# CITY OF ALBUQUERQUE

RE: **Andalucia Phase I – 6500 Coors NW**  
**Grading Management Plan and Grading and Drainage Plan**  
**Engineer's Stamp Date 8-31-2016 (File: E12D015D)**

PROPOSED DRAINAGE MANAGEMENT PLAN

C-001

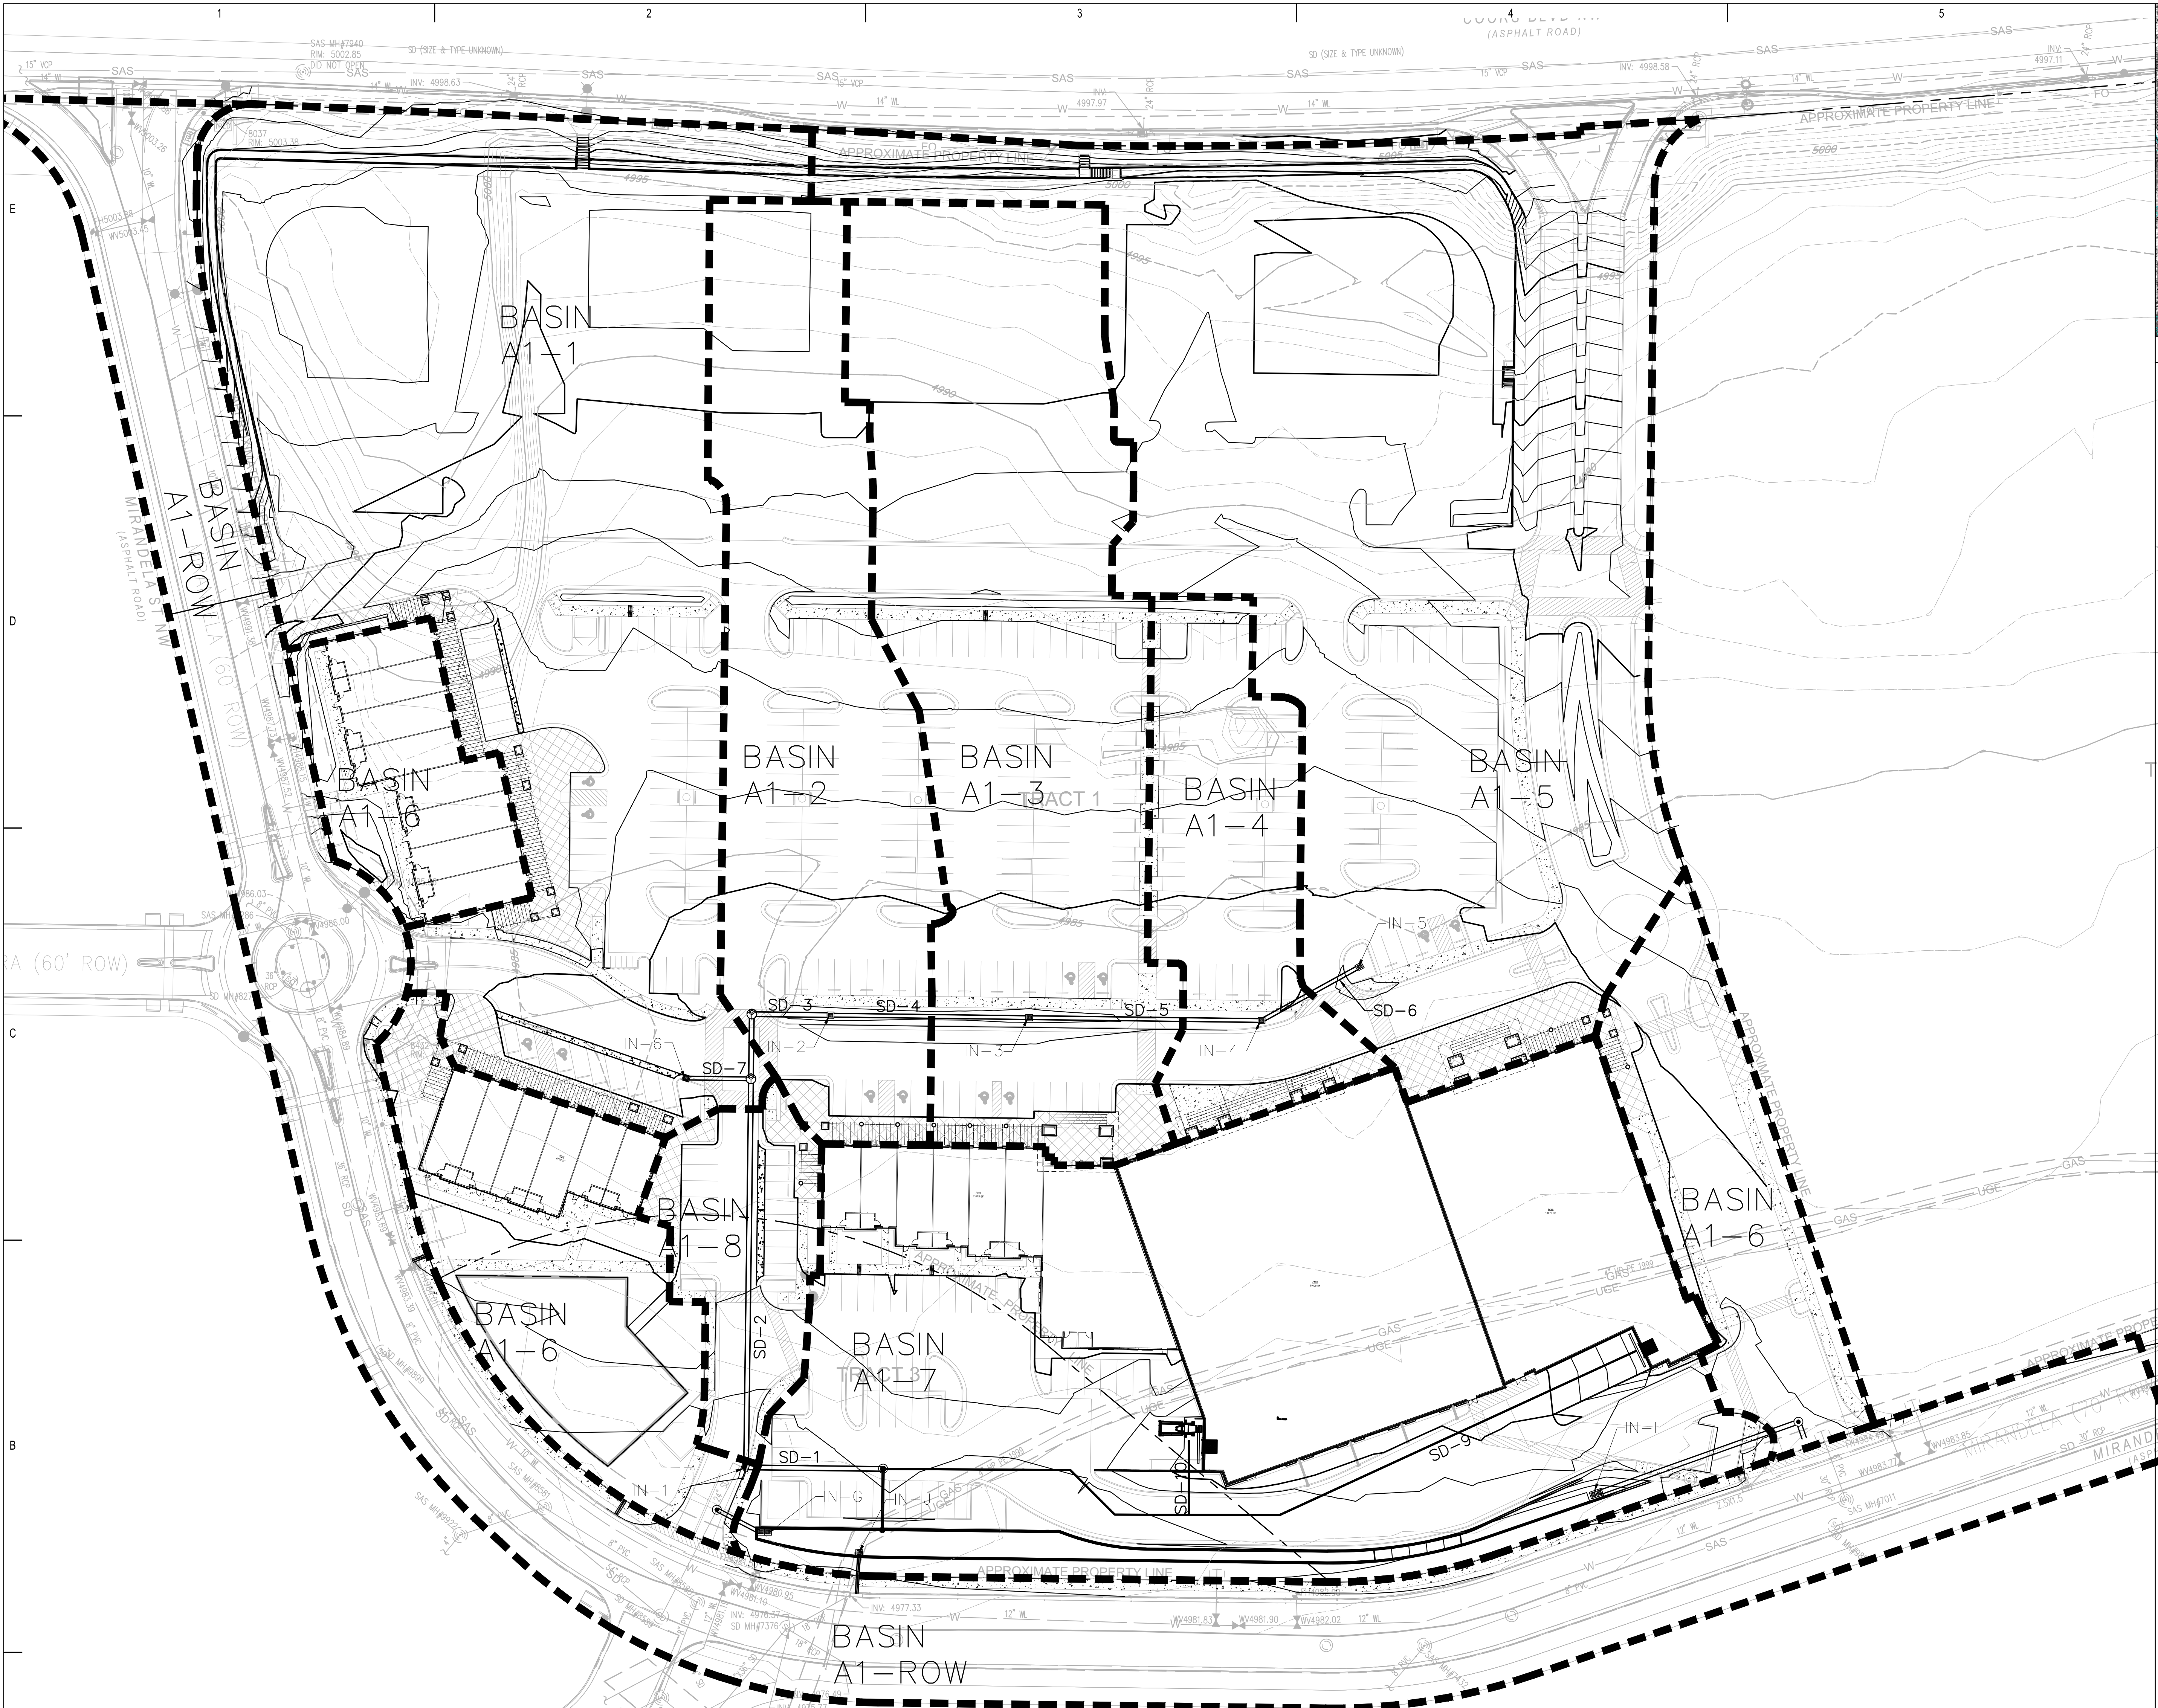
- The bottom of the pond will need to be lowered to 74.50 to allow for 0.5 ft of freeboard. The inlet grate elevations will need to be lowered (80.85), as well as the corresponding inverts.
- Inlet at north side of pond-lower the inlet grate elevation to match the other inlets
- Provide curb openings along median on private road on north side of site
